PLANS AND DOCUMENTS
referred to in the PDA
DEVELOPMENT APPROVAL

Approval no: DEV2021/1235

Aura Precinct 15 – Land Lease Community

Prepared for Stockland Development
Pty Ltd

Figure 1. Context Plan (Urbis)

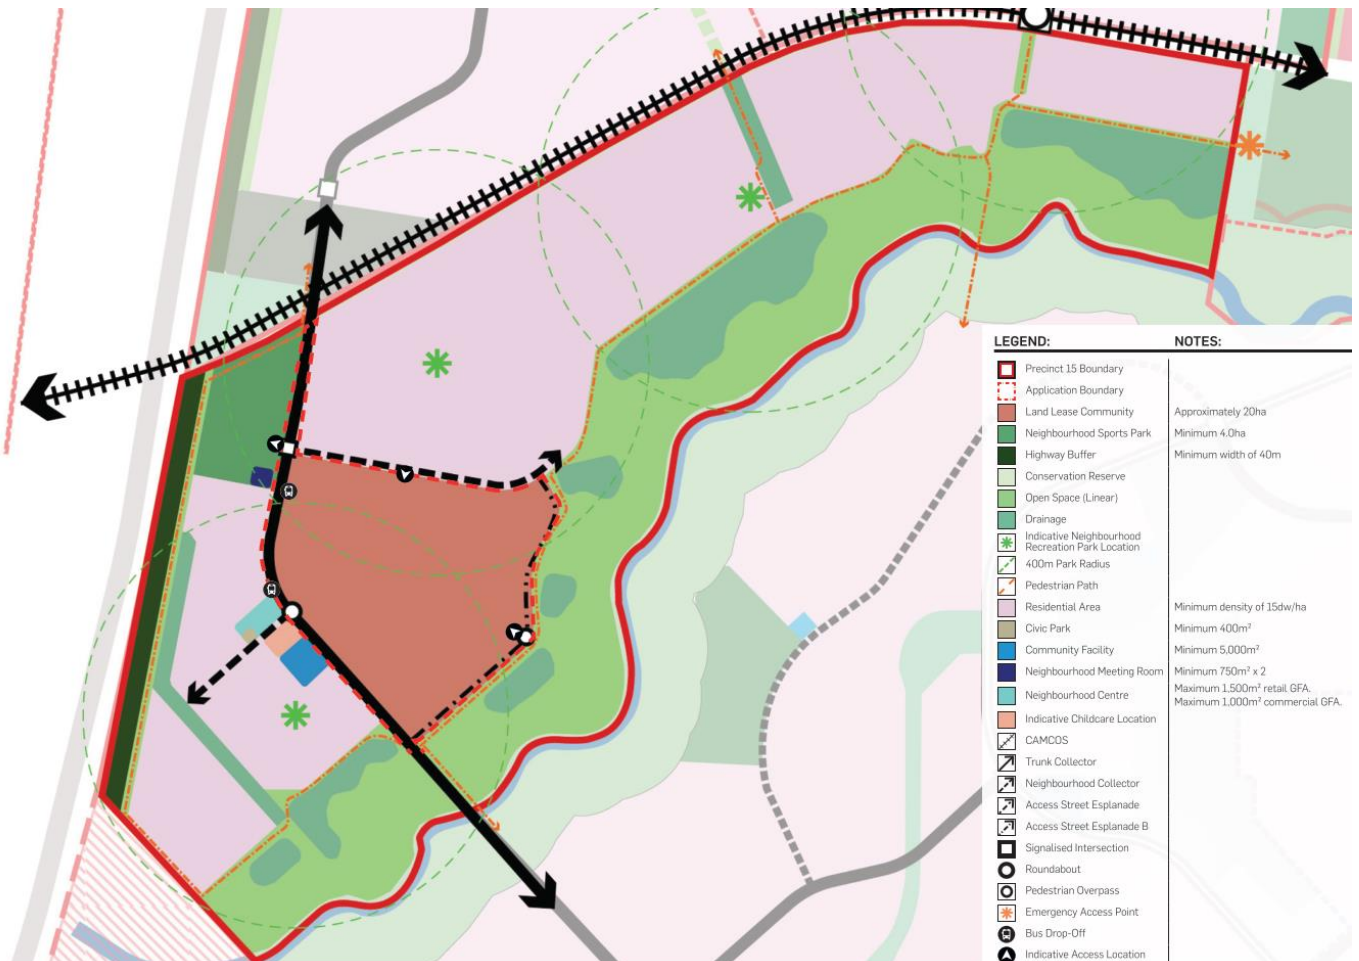
AMENDED IN RED

Refer approved context plan

CONTEXT PLAN

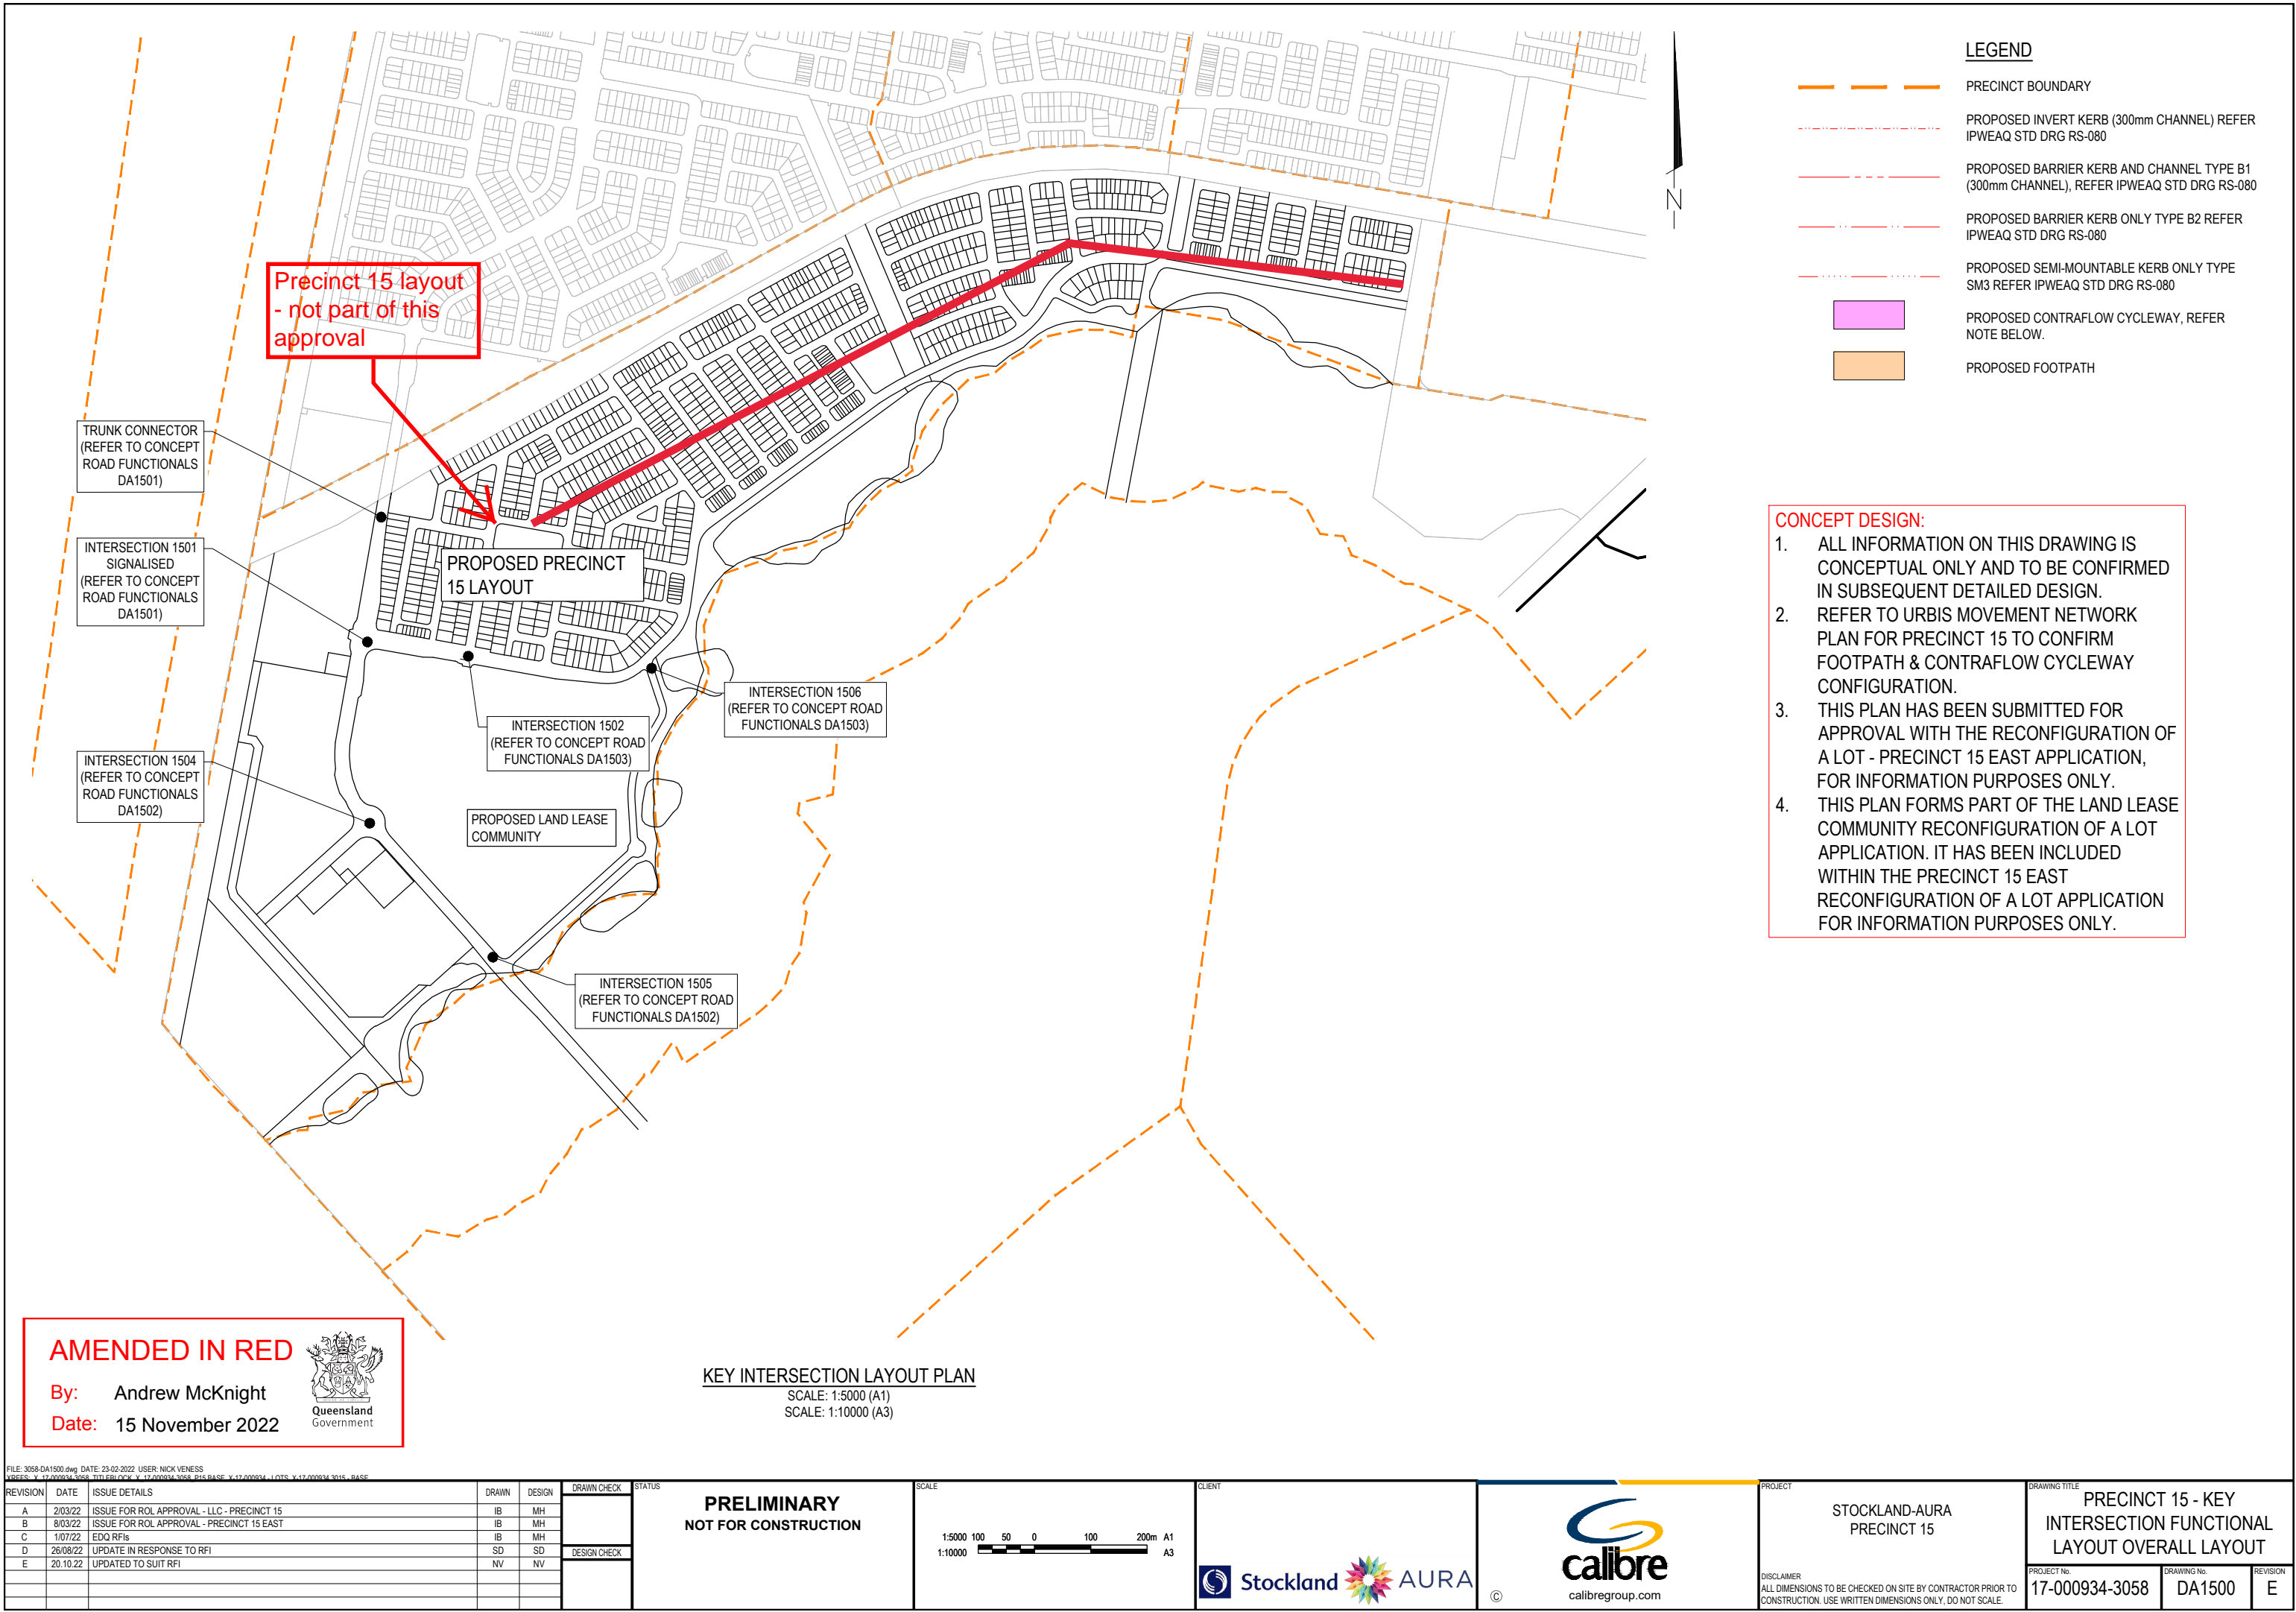
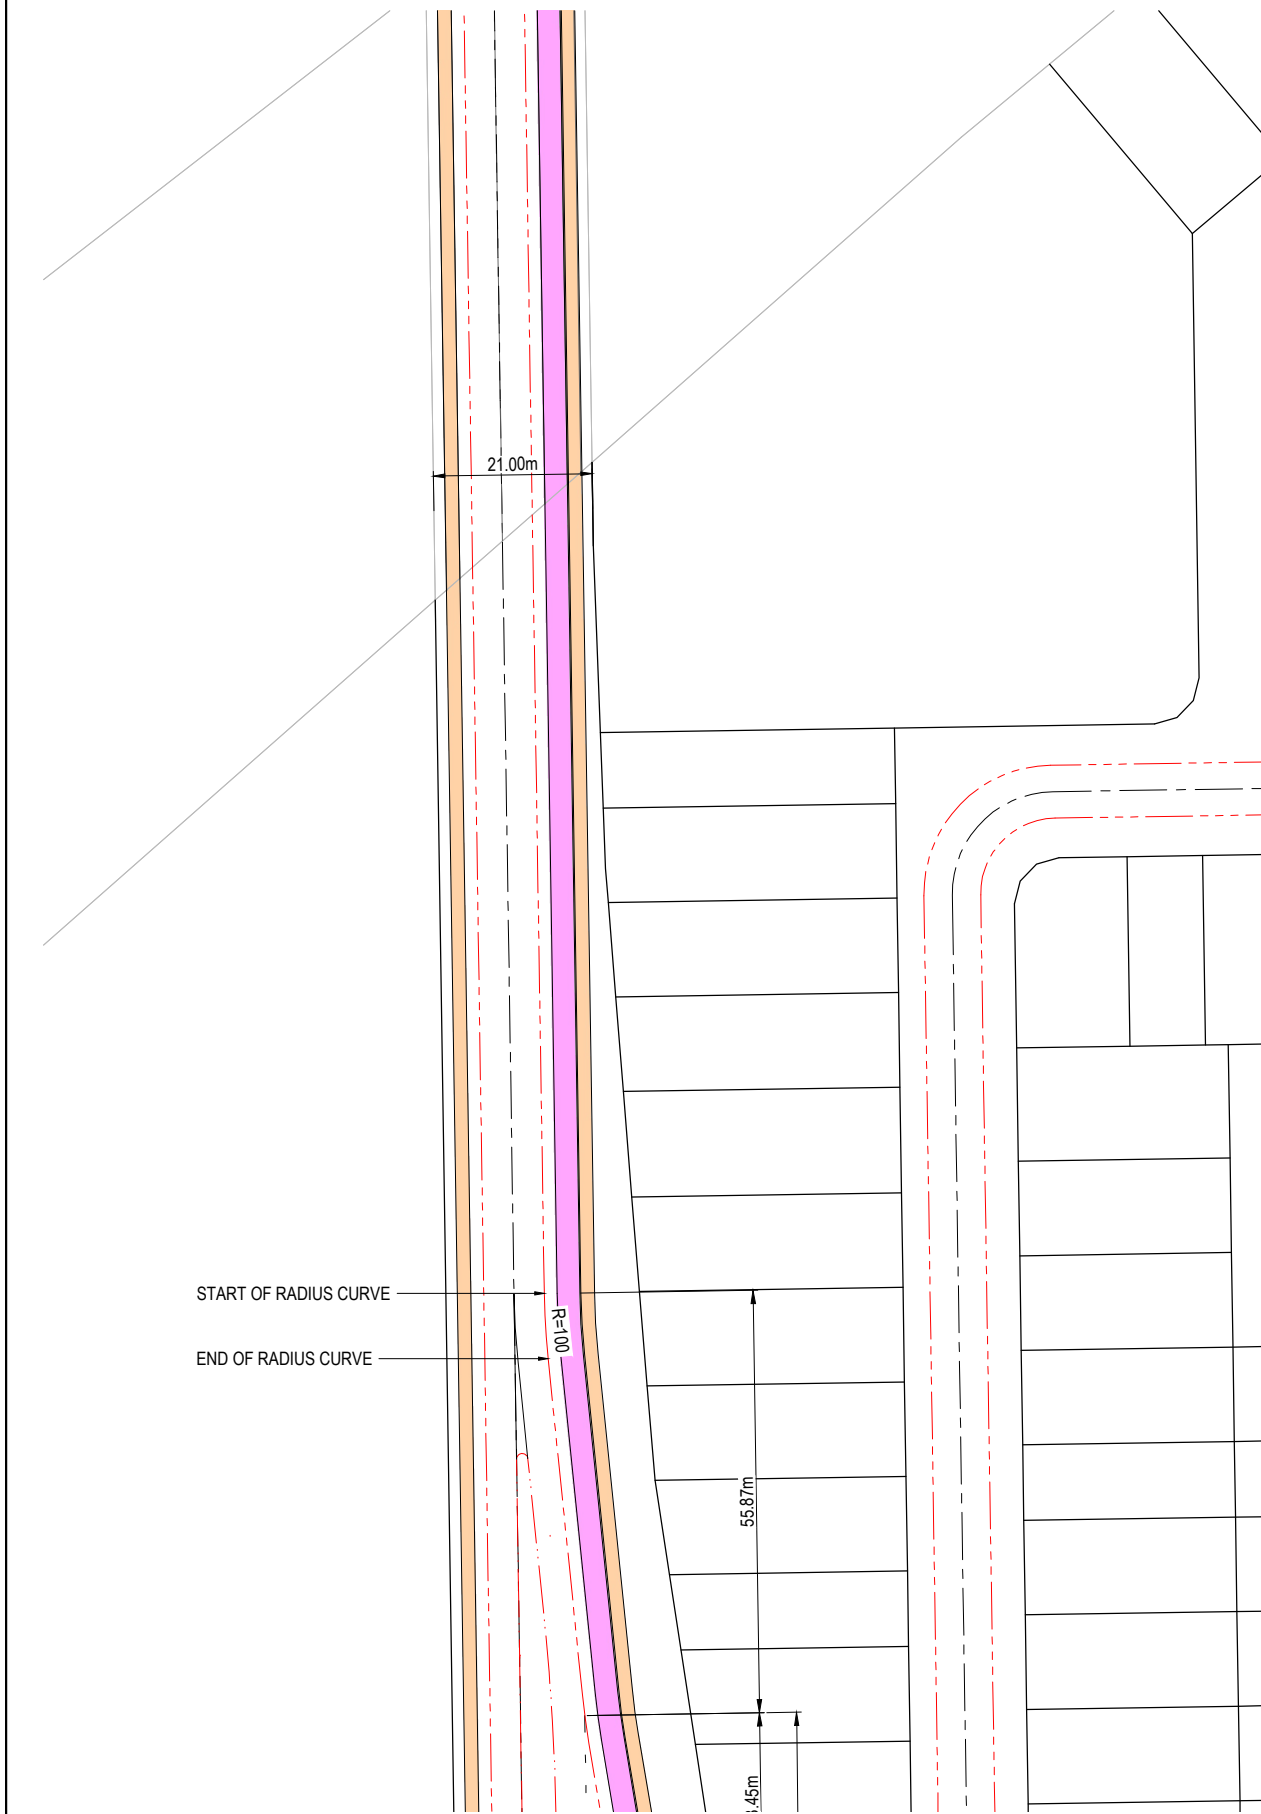
Refer approved context plan
